**SUBDIVISION &
ZONING AMENDMENT STAFF REPORT****Date: March 3, 2016****APPLICANT NAME**

SUBDIVISION NAMEHakanson Subdivision, Resurvey, Resubdivision of a
Portion of Lots 1 – 5, Block 2**LOCATION**1710 Dauphin Island Parkway
(Southwest corner of Dauphin Island Parkway extending to
the Northeast corner of Faye Street and Nicholson Road).**CITY COUNCIL
DISTRICT**

Subdivision Approval to create a single legal lot of record from four legal lots of record and a single metes and bounds parcel; and Rezoning from R-1, Single-Family Residential District and B-2, Neighborhood Business District, to B-3, Community Business District, to allow a car dealership.

DETAIL SITE PLAN

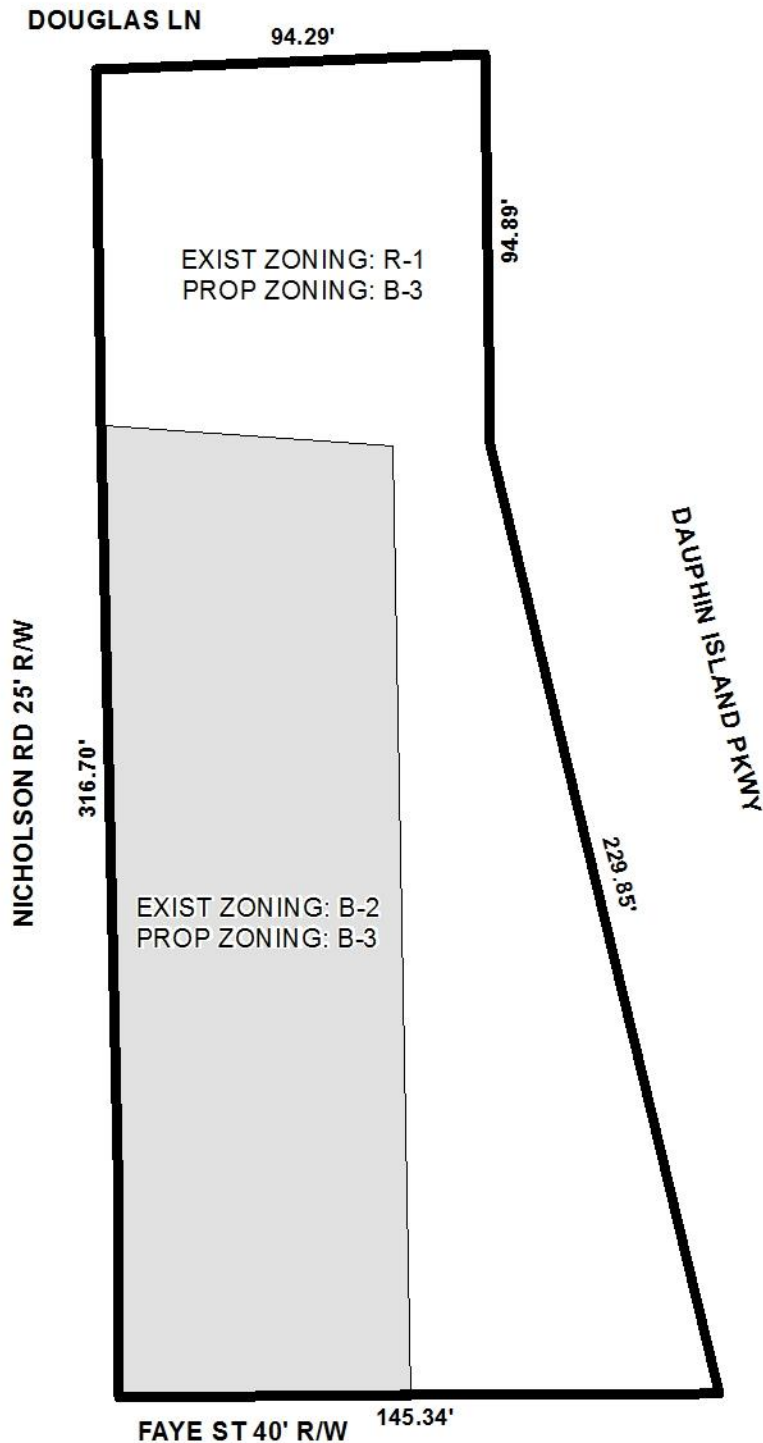
The preliminary plat does not illustrate the 25' minimum building setback. If approved, minimum building setback should be illustrated along all frontages on the Final Plat.

The site plan provided illustrates the existing 700± square foot building, as well as an asphalt parking lot with 10 parking spaces, with portions of the site indicated as "auto inventory lot". It should be noted that the site plan indicates two curb cuts to Nicholson Drive. Because the site

will be limited to one curb cut per street frontage, one of these should be removed and replaced with landscaping.

The site plan does not provide any tree planting or landscape area information. While the applicant is not increasing or decreasing the size of the structure on the site, the rezoning aspect should require full compliance with tree planting and landscaped area regulations.

The proposed site plan does not indicate a dumpster on the site. If approved, the site plan should be revised to indicate either a dumpster connected to sanitary sewer and an enclosure in compliance with Section 64-4.D.9. of the Zoning Ordinance, or placement of a note stating that curb-side pickup will be utilized.

The site plan shows that existing green space will be eliminated to allow for auto inventory. Also, an existing freestanding sign appears to be proposed for removal. While there is substantial landscaping along the Dauphin Island Parkway portion of the site, all of the trees are located in the right-of-way, thus removal or trimming might require Mobile Tree Commission approval.

- 3) illustrate dedication to provide 25' from the centerline of Douglas Lane, if necessary;
- 4) illustration of a 42.5' minimum building setback line along Nicholson Road;
- 5) illustration of the 25' minimum building setback line along all other frontages;
- 6) illustration of full compliance with tree planting and landscape area requirements; and
- 7) depict the removal of one curb cut to Nicholson Road, and replacement with landscaped area.
